RE: DRAINAGE REPORT FOR VOLCANO VISTA (E-10/D9)
RECEIVED FEBRUARY 23, 1993 FOR PRELIMINARY PLAT & ROUGH GRADING APPROVAL
STAMPED & DATED 2-22-93

VOLCANO VISTA SUBDIVISION, UNITS 1 & 2 DRAINAGE PLAN

VOLCANO VISTA SUBDIVISION UNITS 1 & 2	
GRADING & DRAINAGE PLAN	
DESIGN D.B.T.	DRAWN K.I.S.
WILSON & COMPANY	
6611 GULTON CT ALBUQUERQUE, NEW MEXICO 87109 (505) 345-5345	
DATE JAN 1993	FILE NO. 92-549
SHEET NO. 1 OF 1

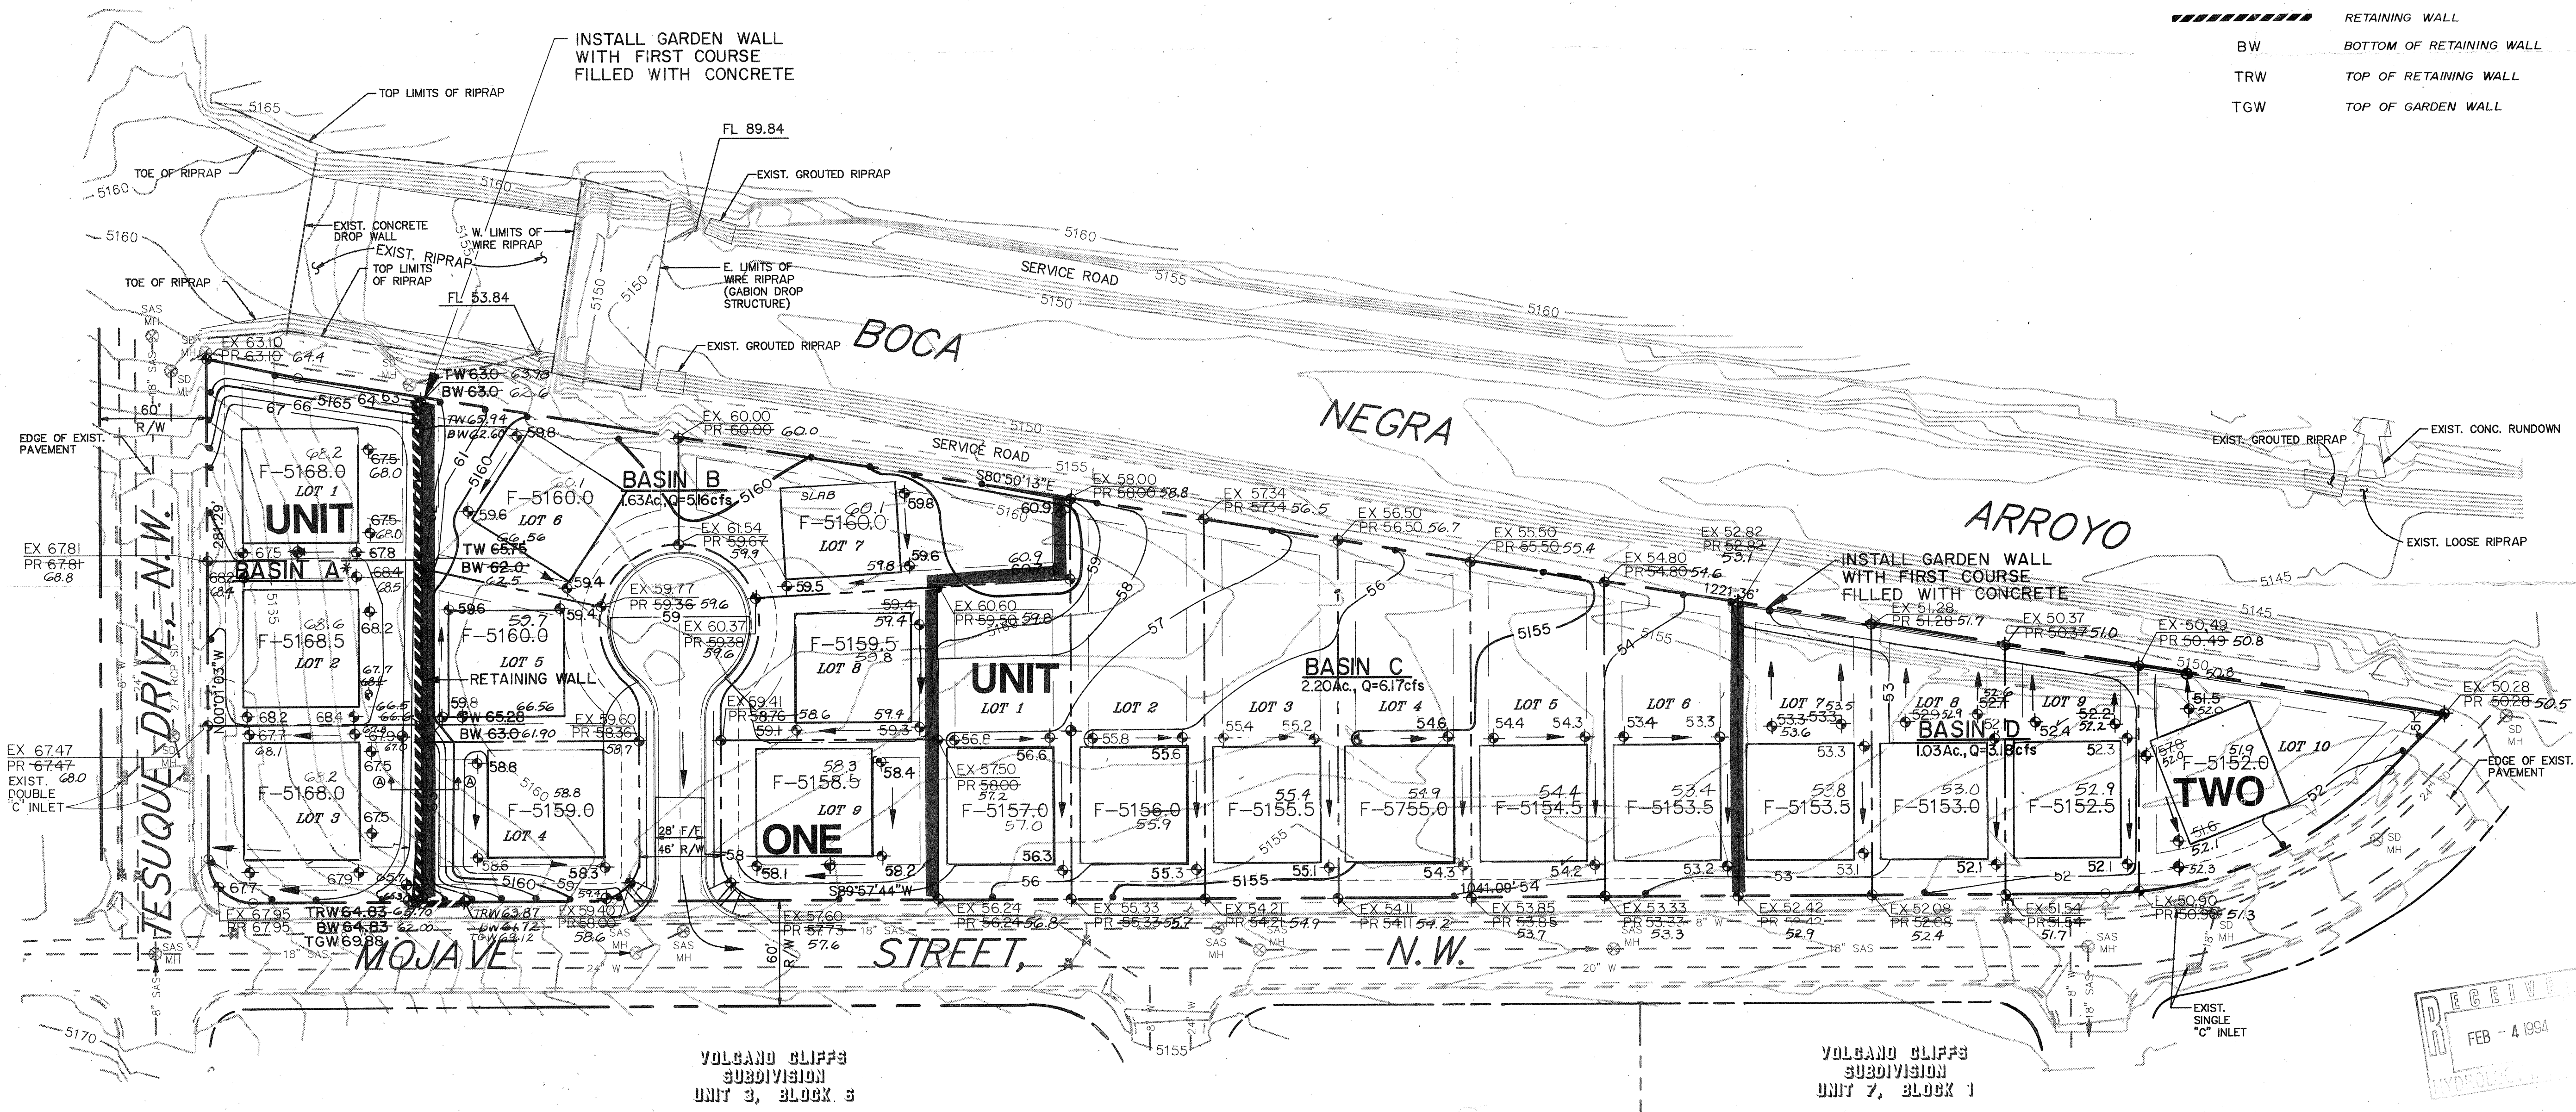
All roof drains must drain to the street not the backyards.

The concrete rundown channels will each require a private drainage easement. All roof drains must drain to the street not the backyards.

City Hydrology requests that each lot have existing & proposed spot elevations at every other property corner.
